WAIAWA INTERCHANGE

STRUCTURE 16

LAYOUT PLAN
& LONGITUDINAL SECTION

WAIAWA INTERCHANGE
F.A.I. Proj. No. I-HI-1 (75):8

DECK FRAMING PLANS

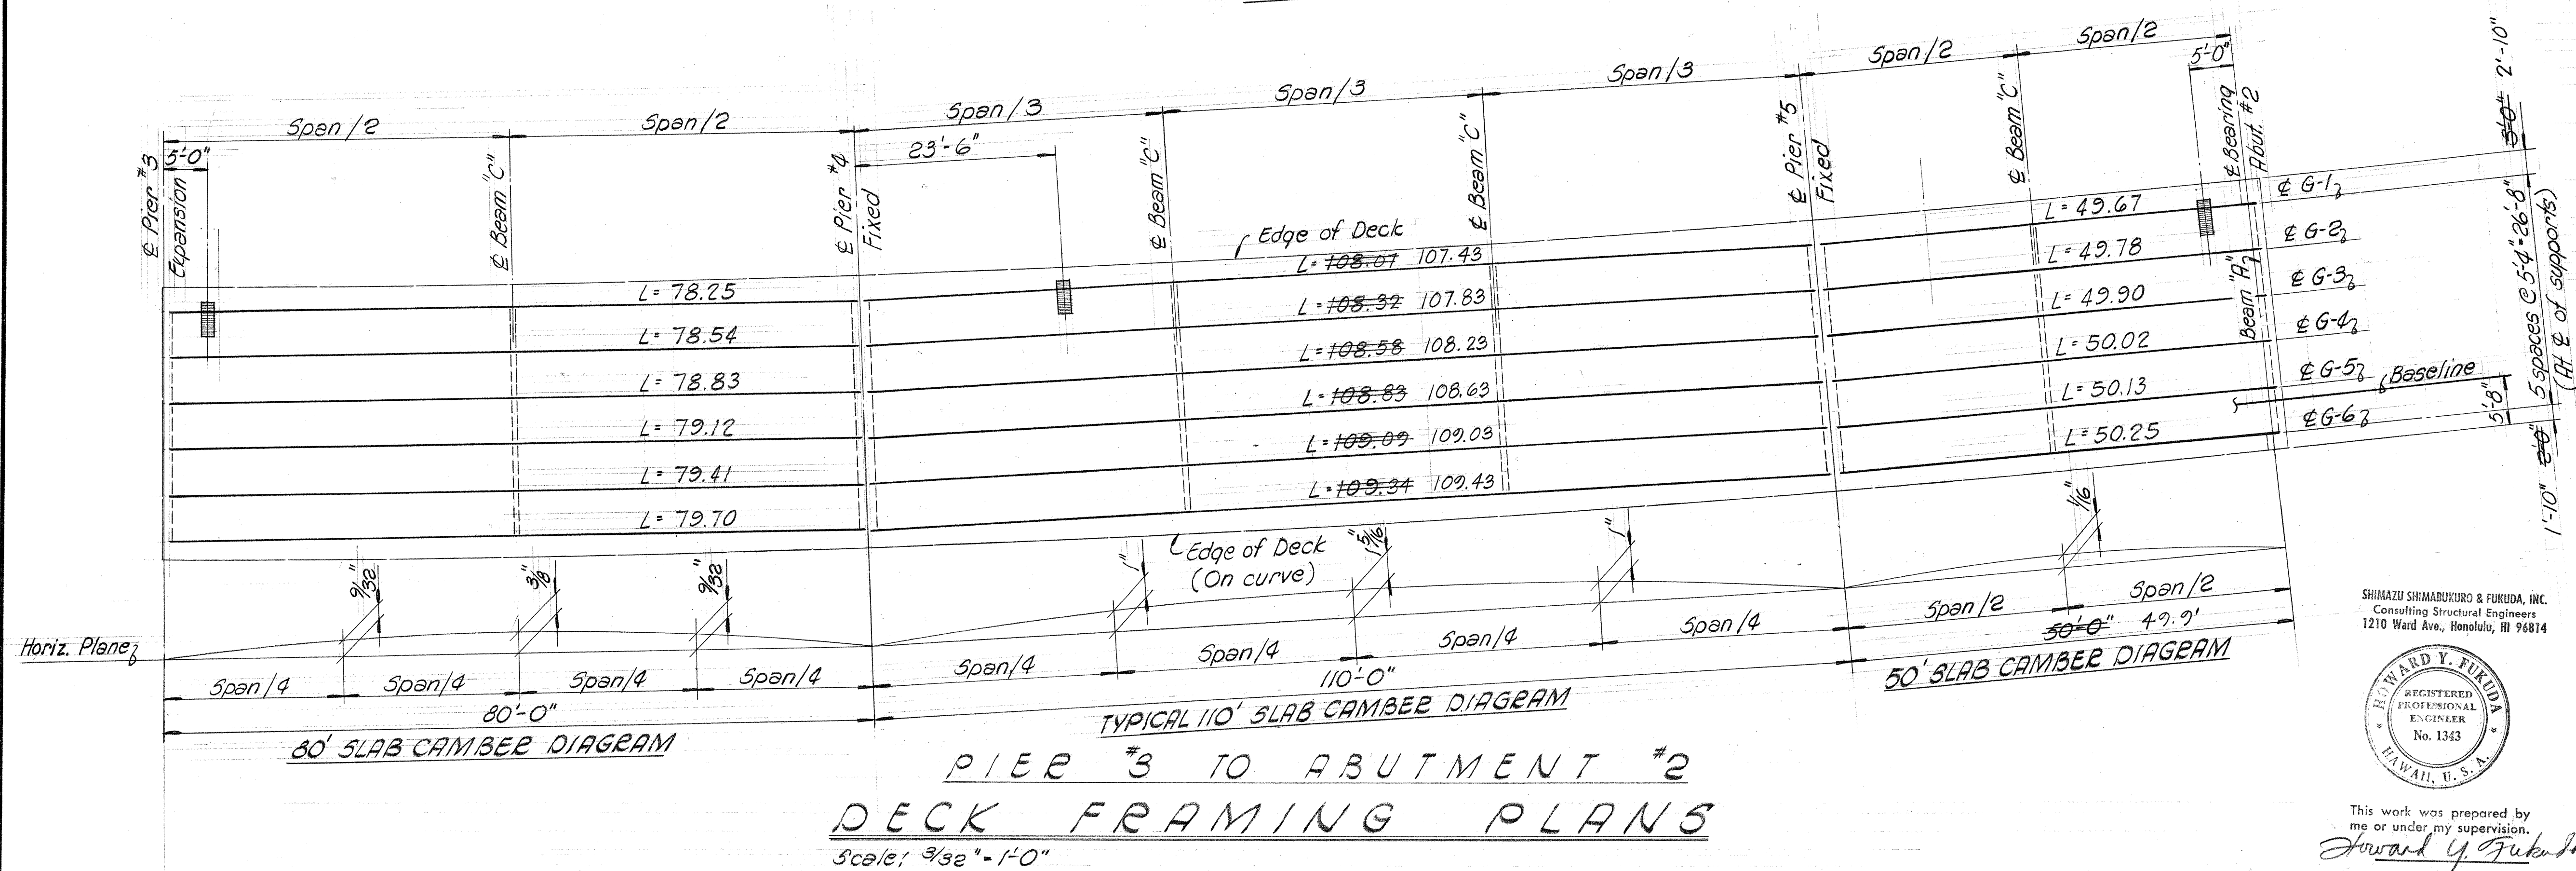
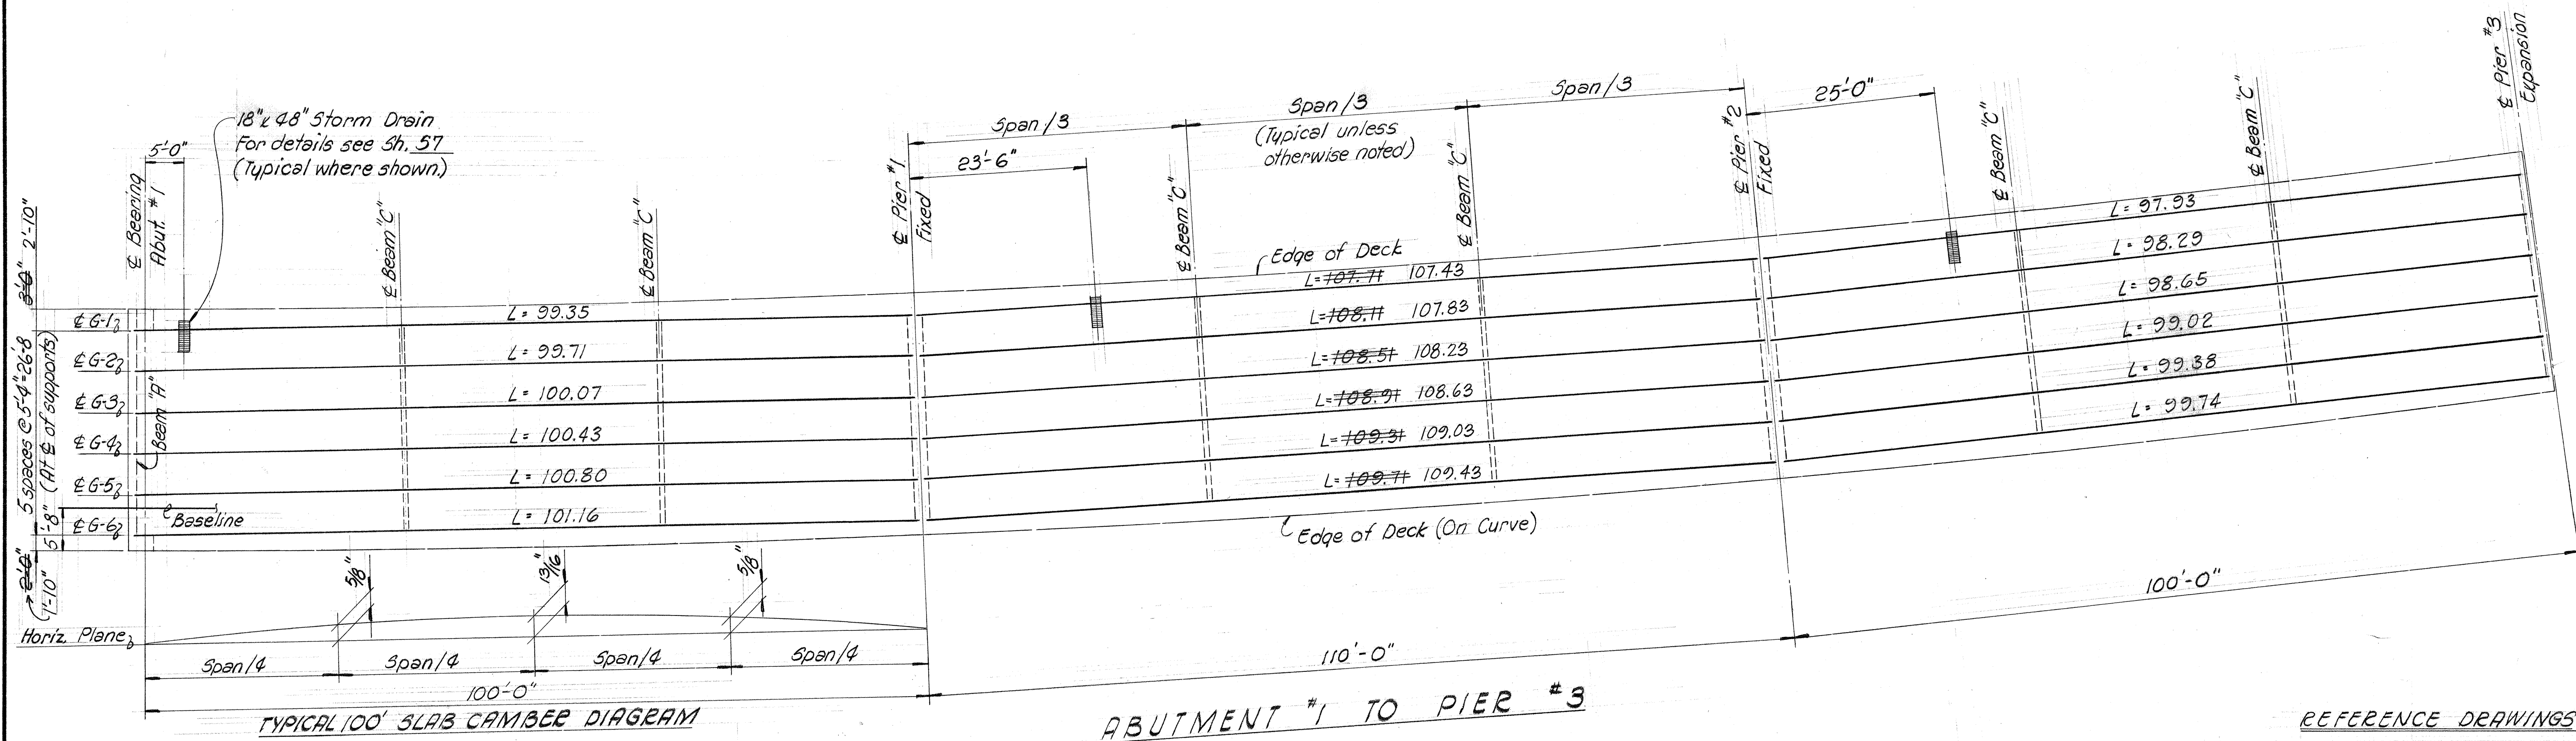
<u>DATE</u>	<u>REVISION</u>
March 30, 1971	changed girder lengths and dimensions.
